**CITY OF TEMPE  
DEVELOPMENT REVIEW COMMISSION**

**Meeting Date: 04/10/2018  
Agenda Item: 5**

**ACTION:** Request an Amended Planned Area Development Overlay, a Use Permit for tandem parking spaces, and a Development Plan Review for a new 21-story, mixed-use development consisting of 269 dwelling units and commercial uses for THE COLLECTIVE, located at 708 South Myrtle. The applicant is Gammage & Burnham PLC.

## THE COLLECTIVE

Drawing Title  
**REFUSE AND FIRE ACCESS PLAN**

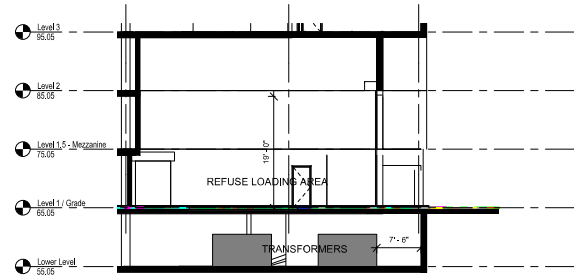
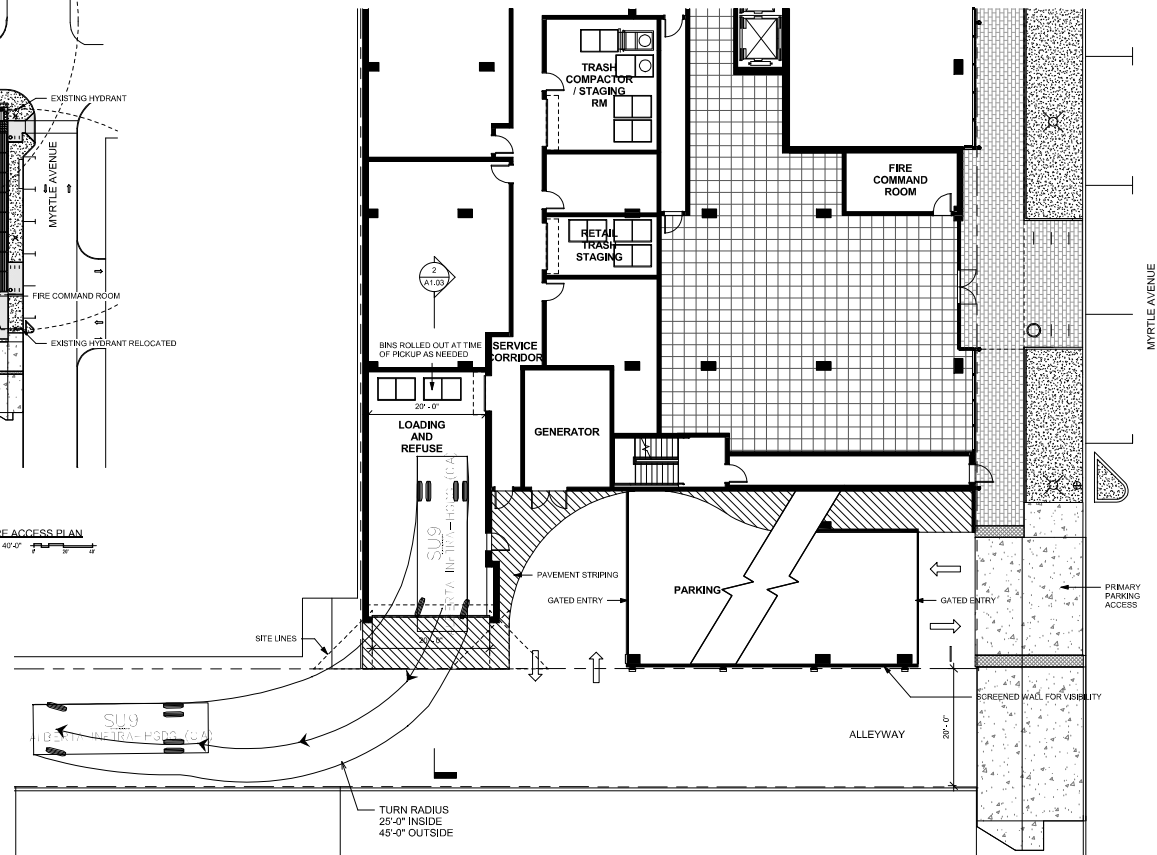
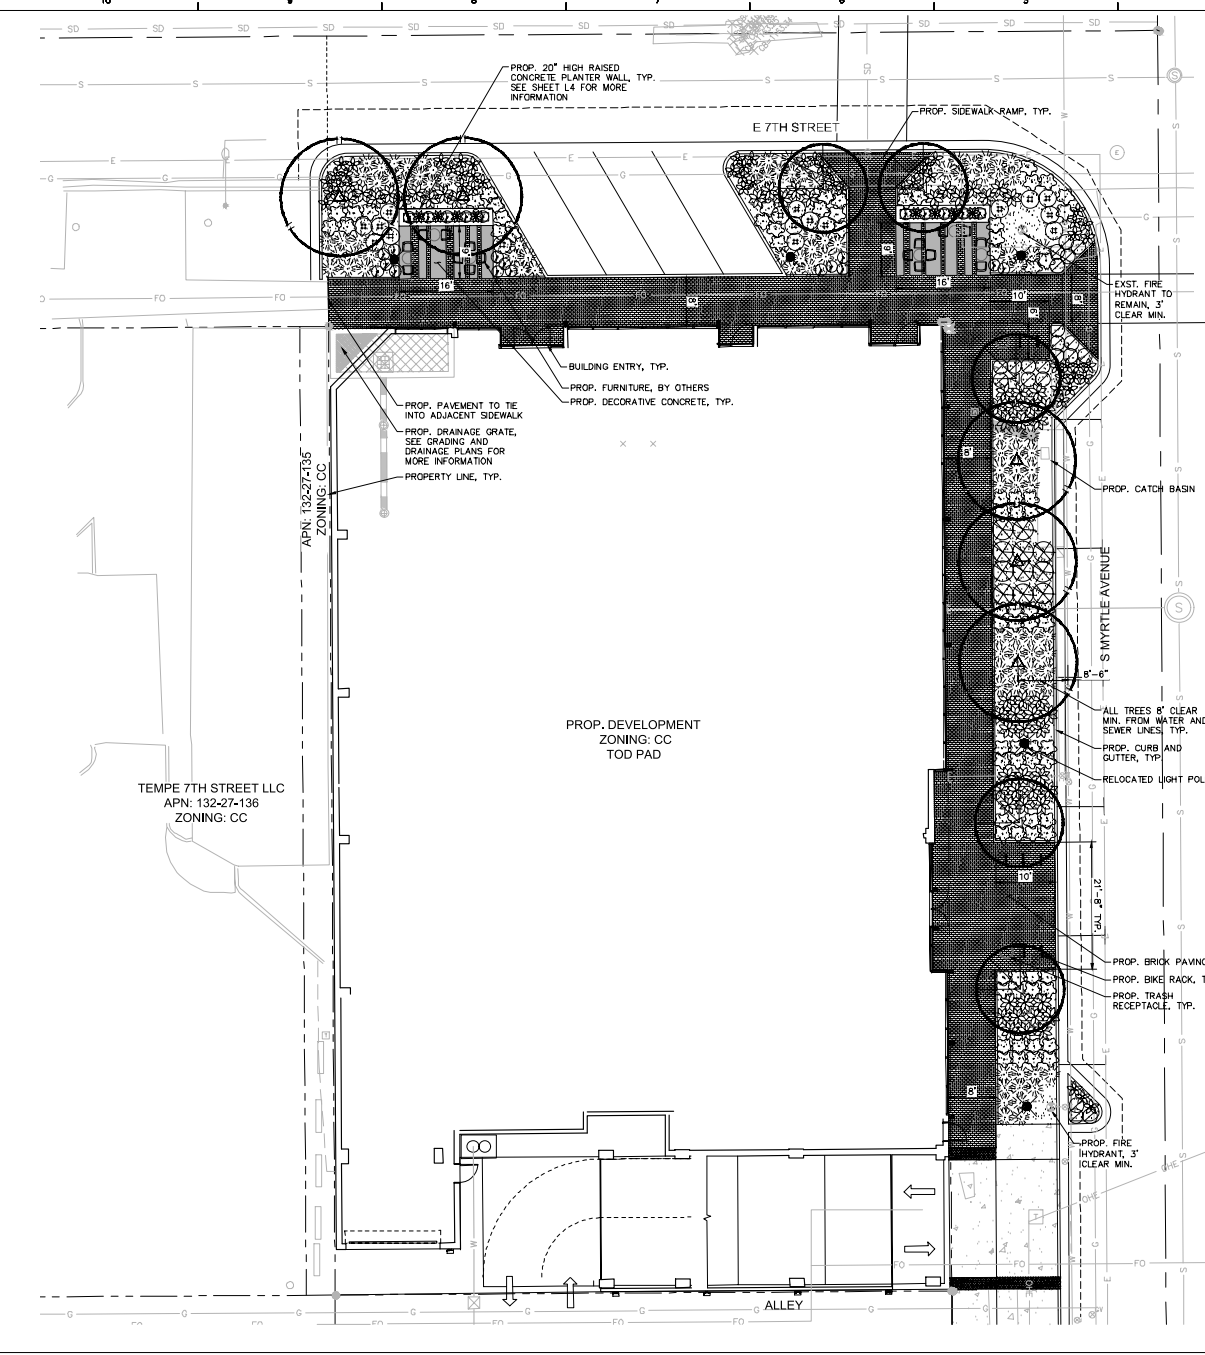
4. Provide service locations as shown on the Refuse and Fire Access Plan for both refuse and recycling collection and pick-up on the property.
5. If needed, provide service yard and mechanical (cooling tower/generator) yard walls that are at least 8'-0" tall as measured from adjacent grade and are at least the height of the equipment being enclosed, whichever is greater. Verify height of equipment and mounting base to ensure that wall height is adequate to fully screen the equipment.

Date: 02/26/2018  
Drawn By: RAS  
Checked By: AJAY  
Project No.: ---  
Epsilon 09/20/2018  
Drawing No.: L3

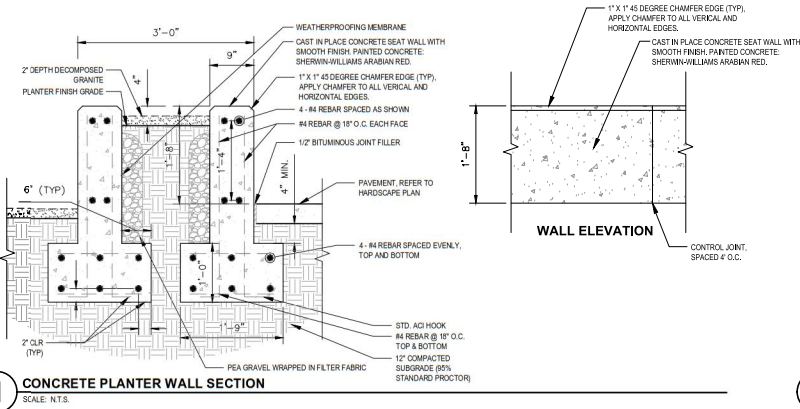
10. **Landscape at the perimeter of the rooftop amenity deck adjacent to 7<sup>th</sup> Street and Myrtle Avenue may not be in pots, as noted on Sheet L3. To maintain a minimum 6'-0" barrier at the perimeter of the amenity deck, landscape must be planted directly into the planter bed. Alternatively, the wall may be shifted inwards with potted plants used exterior to the wall or the wall may be raised to achieve a minimum height of 6'-0" above the top of pots.**

Drawing No.  
**A9.11**

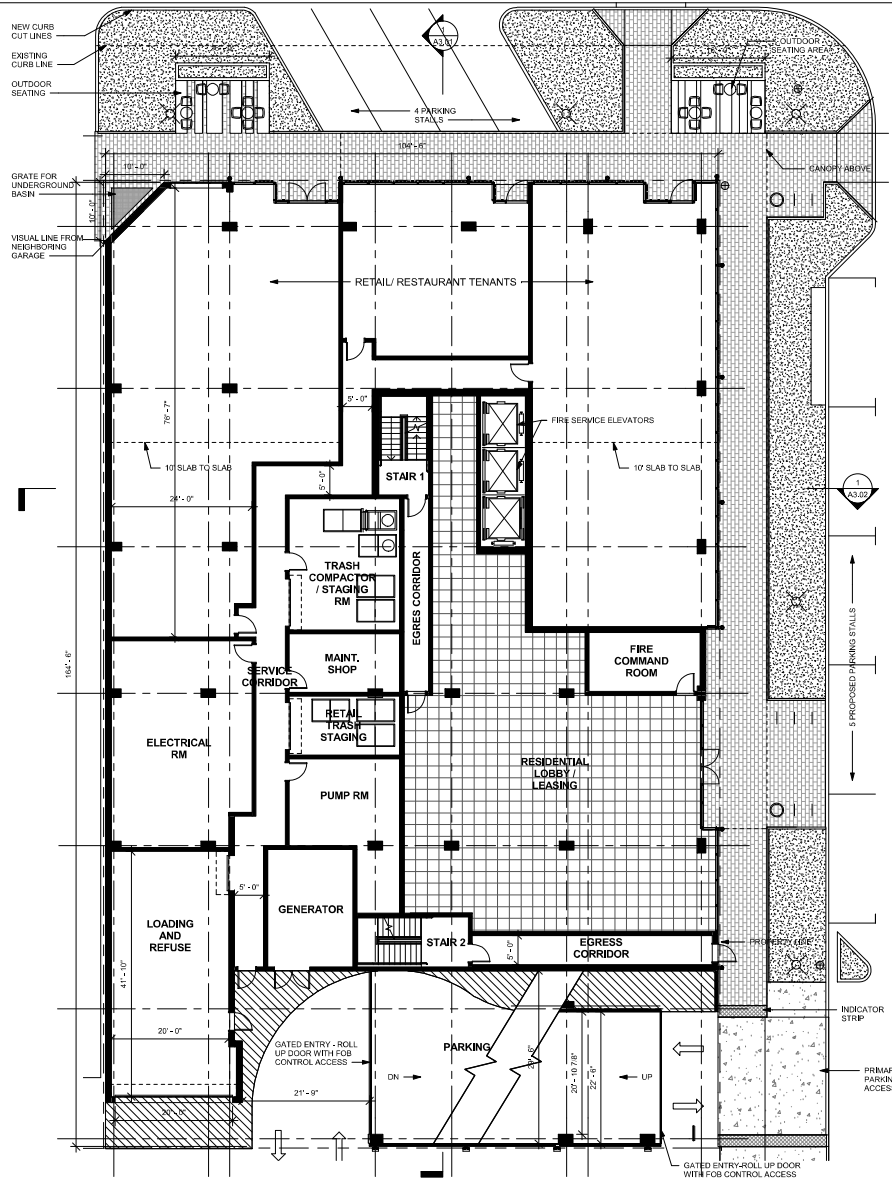
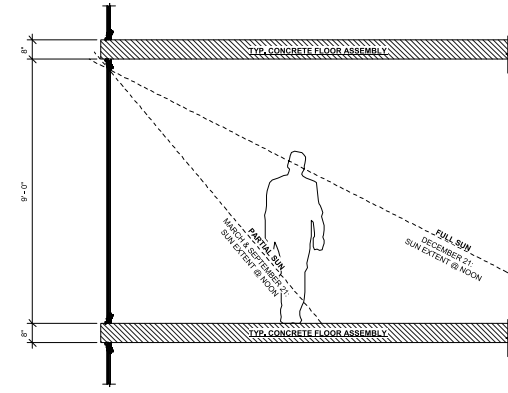
9. **The height of the wall surrounding the above grade amenity deck adjacent to 7<sup>th</sup> Street and Myrtle Avenue shall be a minimum 6'-0" high, measured from floor grade, rather from bottom of planter bed as is shown on Sheet A9.11, Detail 4. Landscape planters shall be located on either the exterior or interior of the wall to act as a buffer from the building edge.**
